JR Response in green
box with black letters

**FINAL DRAINAGE REPORT
FOR
STERLING RANCH FILING NO. 4**

**November 18th 2022
Project No. 25188.11**

**PCD Filing No.:
SF-22-030**

STERLING RANCH FILING NO. 4
PROPOSED DRAINAGE MAP
JOB NO. 25188.11
11/18/2022
SHEET 1 OF 2

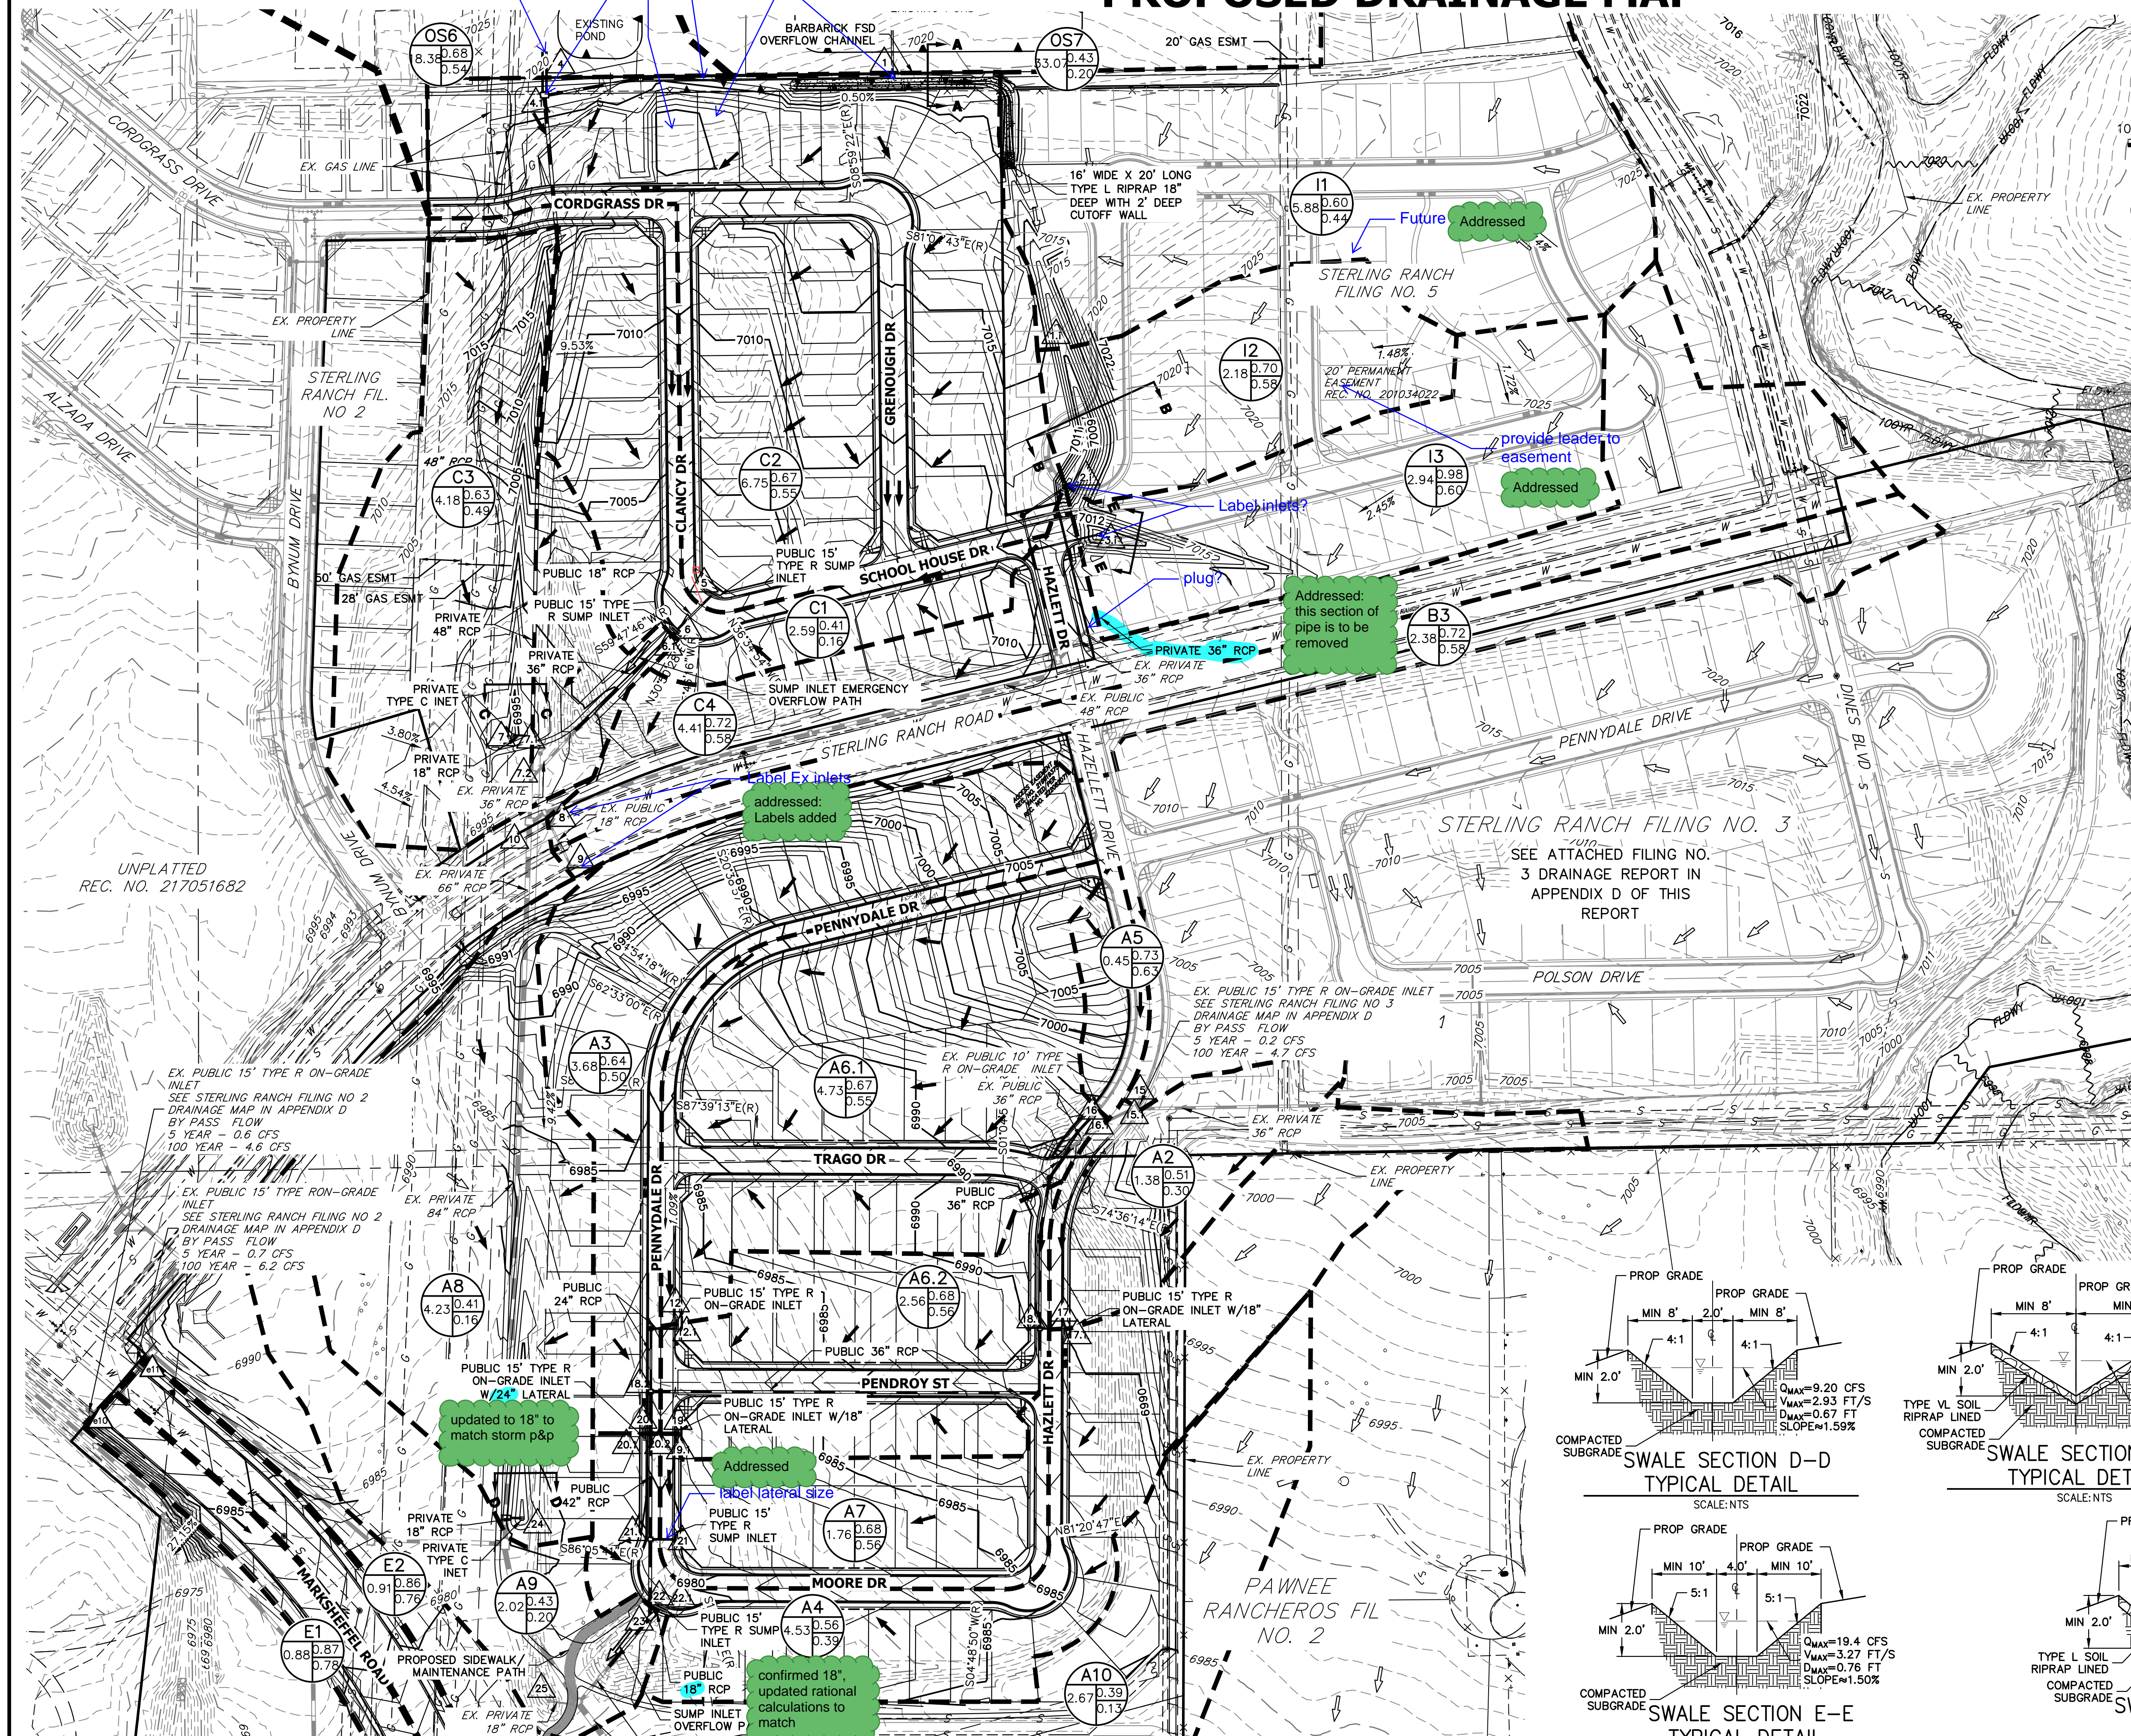
verify that this is undetained flow or emergency overflows will still be contained in the channels

Emergency over flows will be contained within the channel, at peak flow the water will be at a depth of 1.51' and the channel is 2.0' deep minimum.
